616 020 0015/HD*

Tie rod end to fit Opel Astra J, Insignia

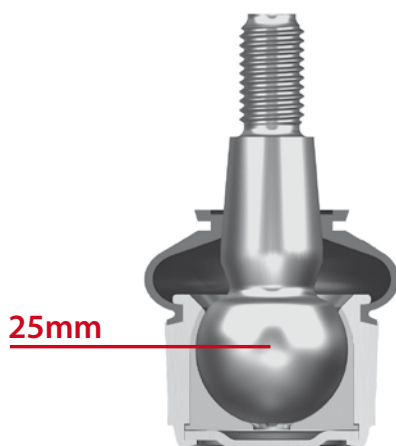
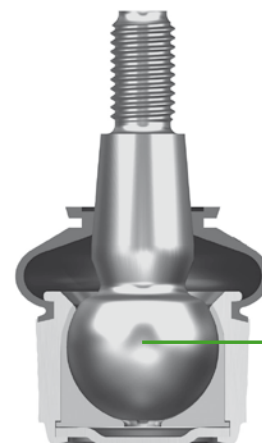
Intense strain and high surface pressure wears on the tie rod end (head \varnothing 25mm)

Noise and play in the steering

Increased diameter of the ball head of the tie rod end to 27 mm

Reduction of the surface pressure ensures a significant longer lifetime
